RE: Takoma Junction development – SHA Tracking #19-AP-MO-008-xx) Response Letter of May 17, 2021

RE: Takoma Junction
MDOT SHA Tracking # 19-AP-MO-008-xx
Our Job No.: 2016-0409

This letter responds to comments received from the Maryland Department of Transportation State Highway Administration (MDOT SHA) in a letter dated May 17, 2021, in reference to the review of the Concept Plan for the Takoma Junction development.

Figure 9-17. Departure Sight Triangles for Intersections

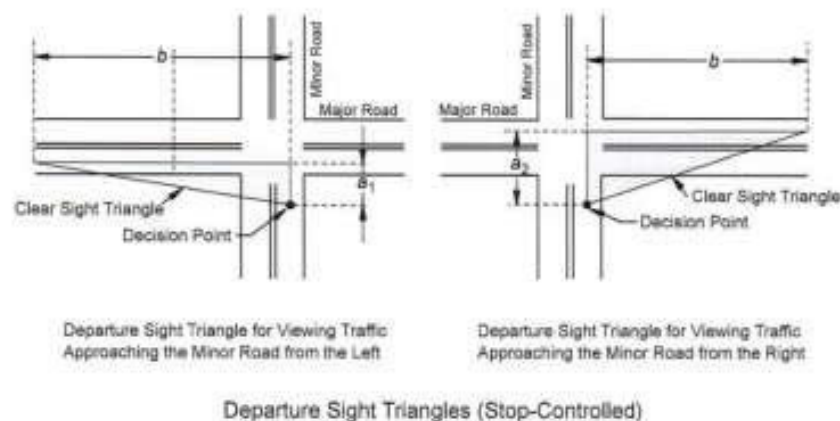
- The sight distance measurements were not conducted in accordance with professional standards of practice as specified by the American Association of State and Highway Transportation Officials (AASHTO). Please refer to the AASHTO Green Book for the appropriate methodology. The Institute of Transportation Engineers Manual of Transportation Engineering Studies and the Traffic Engineering Handbook provide additional guidance. Sight distance identified as dimension b below (for intersection sight distance), is measured as part of an intersection sight triangle with a decision point located 14.5 feet from the edge of the major road traveled way. Figure 9-17 from the AASHTO Green Book copied below illustrates.
 - o Sightlines are measured along a straight line
 - o Sightlines do not curve with the vehicle path
 - o Sightlines do not curve around objects

Related object heights are as indicated in the Manual. Please revise accordingly.

1. The “Intersection Sight Distance” information that is included above is in fact “Intersection Sight Distance” Evaluation information. As mentioned above, in earlier response letters and in our presentation, we agree and acknowledge that we do not meet “Intersection Sight Distance” measurements because of existing buildings along the roadway.
2. However, please see the attached 2018 AASHTO Exhibit 9.5 Intersection Sight Distance – 9.5.1 General Considerations, last paragraph highlighted:

At uncontrolled or minor approach stop controlled intersections, sight distance along the intersecting roadway should be sufficient to permit the driver on the minor road to anticipate and avoid potential collisions. If the available sight distance for an entering or crossing vehicle is at least equal to the appropriate stopping sight distance for the major road, then the drivers have sufficient sight distance to anticipate and avoid collisions. However, in some cases, a major-road vehicle may need to slow or stop to accommodate the maneuver by a minor-road vehicle. To enhance traffic operations, intersection sight distances that exceed stopping sight distances are desirable along the major road.

3. The buildings that restrict “Intersection Sight Distances” cannot be moved or relocated.
4. The sight distance restrictions that are present are not restricted due to an over vertical road issue. They are building related. A profile diagram would not show over vertical sight line issues.
